GROUP	MODEL
Safety Recall Campaign	2010-2011MY Rondo (UN)
NUMBER	DATE
SC284UN	June 2024

### HECU FUSE REPLACEMENT (SC284UN)

This bulletin provides information to replace the fuses of the Hydraulic Electronic Control Unit (HECU) and install an updated junction box label on certain 2010-2011MY Rondo (UN) vehicles produced from September 19, 2009 through February 9, 2011. An engine compartment fire may occur in the area where the HECU is located. The HECU may experience an internal electrical short circuit condition that can result in overcurrent, thereby increasing the risk of an engine compartment fire while the vehicle is driven or while parked. Dealers are to install new fuses to prevent an electrical short circuit condition in the HECU's electrical circuit board. Customers may experience illumination of the Malfunction Indicator Lamp (MIL), ABS warning light, burning/melting smell, and/or smoke from the engine compartment. Follow the procedure outlined in this publication to install new fuse(s) and junction box cover label(s) on the applicable vehicle. Before conducting the procedure, verify that the vehicle is included in the list of affected VINs.

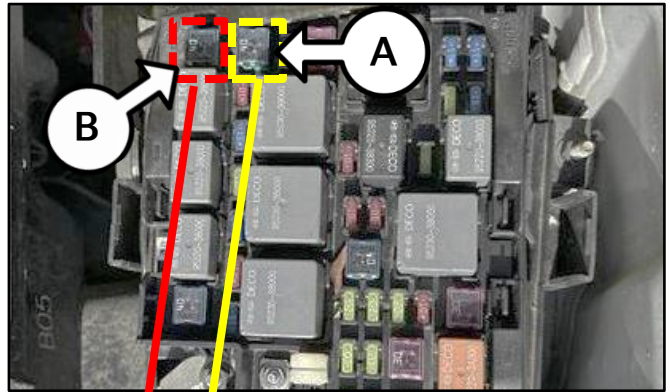
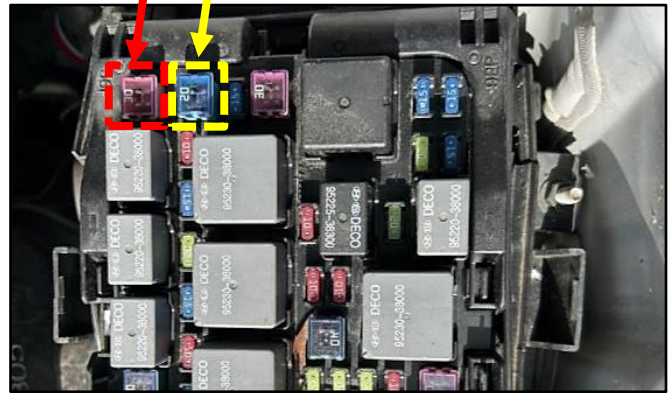
- 3a. Remove both existing HECU ABS1 40A (A) and ABS2 40A (B) fuses.

- 3b. Install new amperage fuses:

- ABS1 fuse (A) → new 20A
- ABS2 fuse (B) → new 30A

Ensure to replace ABS1 fuse (A) with the 20A fuse and ABS2 fuse (B) with 30A fuse.

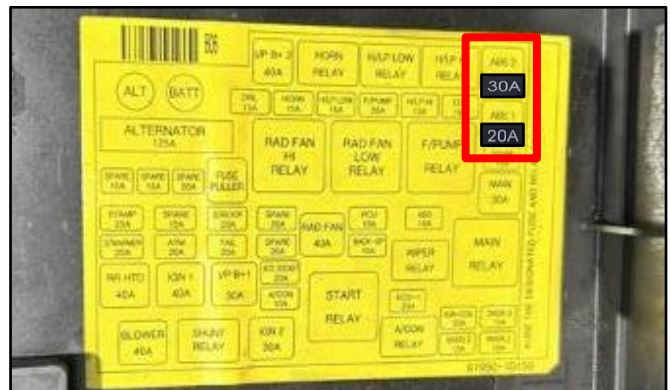
4. Adhere the new ABS1 20A and ABS2 30A labels to the bottom of the junction box fuse cover, as shown.
